Commercial Element Construction Management Plan

(Rev 05)

Camden Town Hall - Lendlease (Dec 2019)

Appendix C - Vehicle Histogram

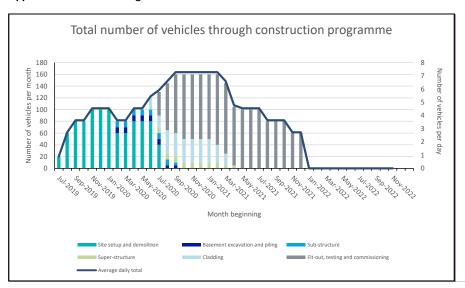
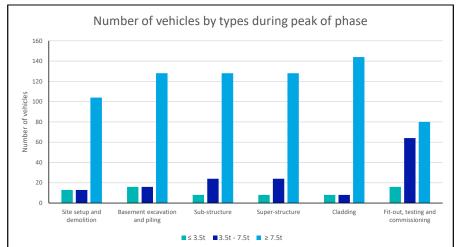
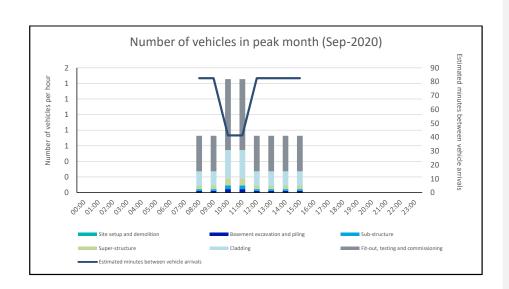
Commented [LM22]: This is showing vehicles arriving in the AM peak. Please amend to be as per times specified above.
